UNITED STATES PATENT AND TRADEMARK OFFICE

APPLICATION NO.	FILING DATE	FIRST NAMED INVENTOR	ATTORNEY DOCKET NO.	CONFIRMATION NO.
10/737,124	12/17/2003	Young-Doug Kim	8947-000074/US	5936

<b>Office Action Summary</b>	<b>Application No.</b> 10/737,124	<b>Applicant(s)</b> KIM ET AL.
	<b>Examiner</b> Khanh Dang	<b>Art Unit</b> 2111

**DETAILED ACTION**

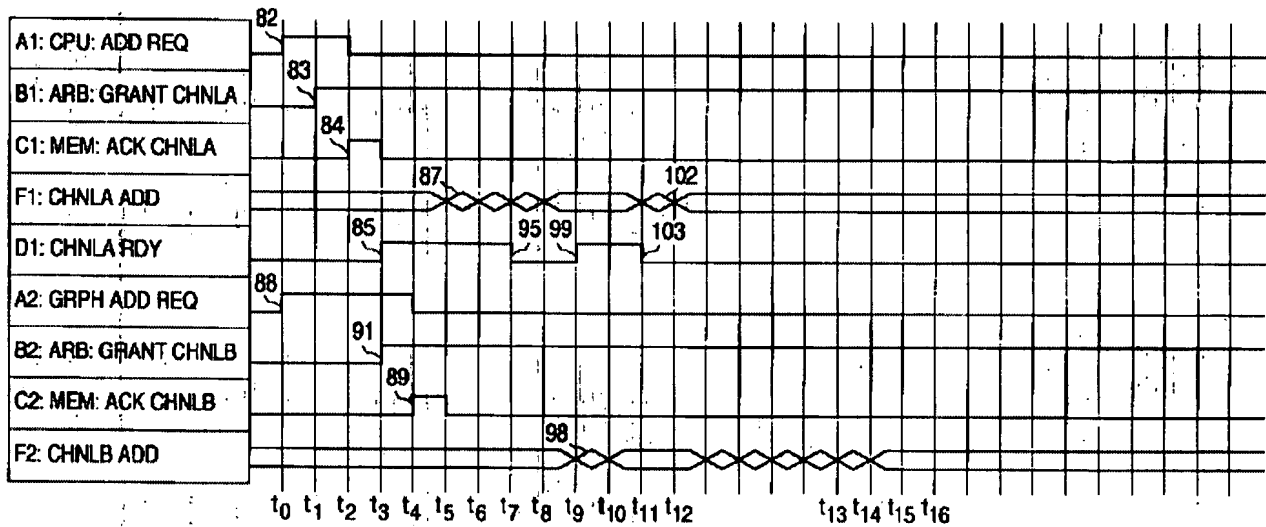
With regard to claim 1, Kenny discloses an arbiter (arbiter 4, Fig. 1, for example) in a system (shown generally at Fig. 1) for generating a pseudo-grant signal to all requesting master units (the arbiter 4 in Kenny "assigns a virtual channel to each master/slave pair requesting the data bus for data transfer between the master module and a slave module. Each virtual channel represents a timeslice on the bus and is owned by a separate master/slave pair, thereby permitting multiple master/slave pairs to have concurrent ownership of the singular data bus" (emphasis added). In another word, the arbiter 4 grants or bus ownership bus grant to the virtual channel of every requesting master before actual arbitration, wherein "data transfer between the master/slave pair commences immediately upon the arbiter asserting the appropriate 'channel active' signal." It is clear that assigning concurrent ownership (bus ownership or bus grant) of a single data bus to each master by the arbiter before actual arbitration is interpreted as providing a pseudo bus grant signal by the arbiter to each master. In

particular, in Kenny, a master module initializes bus access by asserting address and bus request signals on the bus 11. The arbiter 4 and the slave module detect the address and request signals asserted by the master module. The arbiter 4 then identifies the master module making the request, determines the master module's priority, and grants a virtual channel. The virtual channel granted can be arbitrarily selected by an allocation procedure. Specifically, Kenny discloses that "concurrent ownership of the data bus by multiple master/slave pairs advantageously enhances bus accessibility over conventional split-transaction bus protocols since the transactional overhead associated with bus re-acquisition protocols between a master/slave pair is eliminated. Since each channel, hence each master/slave pair, has its own unique channel active signal, data transfer between the master/slave pair commences immediately upon the arbiter asserting the appropriate "channel active" signal." Kenny further discloses that "FIG. 9 is a timing diagram summarizing concurrent transactions of three virtual channels of the present invention." In addition, Kenny discloses that "[a]ll concurrent virtual channel owners wait for an access grant by arbiter 4 to data bus 2. Access to data bus 3 to a particular virtual channel occurs when arbiter 4 asserts the virtual channel's active signal (e.g., CHNLA ACTIVE). Note that in Fig. 9, because the priority of each requesting master (CPU, PCI Controller, Graphics Controller) is not pre-assigned, the arbiter 4 must resolve the priority between requesting masters, and grants virtual channels A, B, C to each requesting master based on priority of each requesting master, by asserting signal GNT CHLNA, signal GNTCHLNB, and signal GNTCHLNC, at times t1, t3, and t5. Fig. 9 is reproduced below:

Kenny also discloses that the arbiter receives transaction information from all requesting master units in response to the pseudo-grant signals (after asserting signal GNT CHNLA, arbiter 4 returns to its initial state 47 to wait for the next ADD/REQ signal from each of the requesting master).

Although Kenny clearly disclose that pseudo-grant signals are generated to all the requesting masters. Kenny, as discussed above regarding Fig. 9, does not particularly disclose that the pseudo-grant signals begin at the same time, as claimed in at least Applicants' claim 1, and shown in Fig. 6, which is reproduced below:

Fig. 6

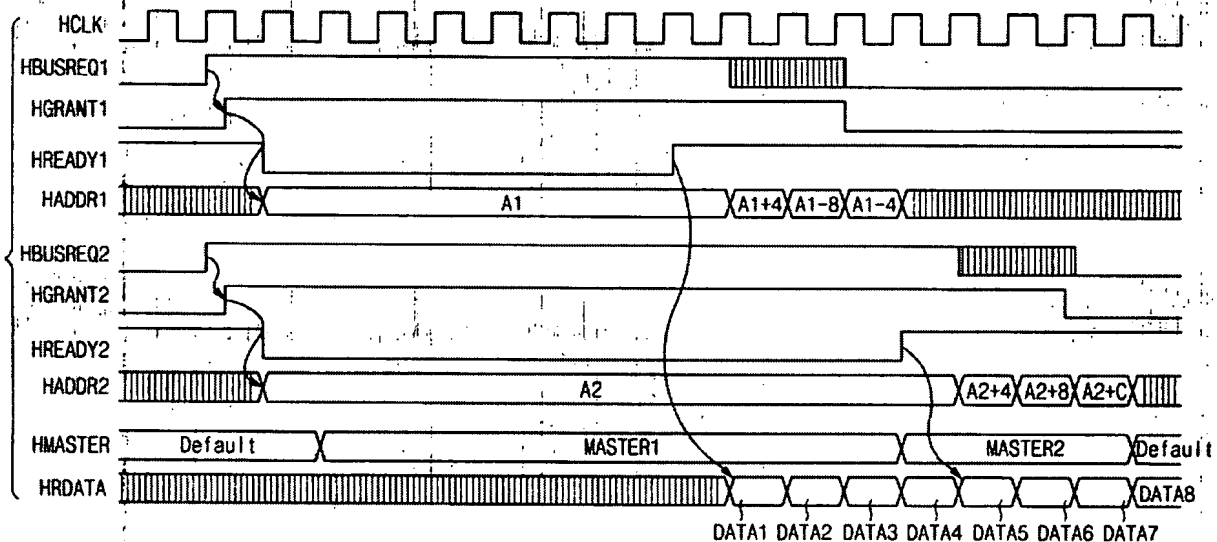
Note that in Fig. 6 above, the pseudo-grant signals HGRANT1 and HGRANT2 begin at the same time.

However, in addition to the timing for pseudo-grant signals as shown in Fig. 9 above, Kenny also disclose that "[a]lternatively, each subsystem may be configured with a fixed virtual channel with a pre-assigned priority. Pre-designating virtual channels and priorities for each module simplifies processing by eliminating allocation procedures and requiring arbiter 4 to merely match the I/O address of the requesting master module to that master module's pre-assigned virtual channel and pre-assigned priority, referencing a table stored in a register of arbiter 4 or elsewhere." Thus, it is clear that by using pre-designating virtual channels and priorities for each module, the arbiter 4 does not have to arbitrate between requesting masters having different priority, and assign a virtual channel to a requesting master according to its priority.

Thus, it would have been obvious to one of ordinary skill in the art at the time the invention was made to generate pseudo-grant signals GNT CHLNA, GNTCHLNB, and GNTCHLNC to all requesting masters beginning at the same time, because by using a fixed virtual channel with a pre-assigned priority for each of the requesting master, the arbiter 4 does not have to arbitrate between masters resulting in generating/providing pseudo-grant signals to all requesting masters at different starting time. Since pseudo-grant signals GNT CHLNA, GNTCHLNB, and GNTCHLNC to all requesting masters begin at the same time, it is clear that arbitration latency can be further reduced, and as a result, the overall performance of the entire system of Kenny is improved.
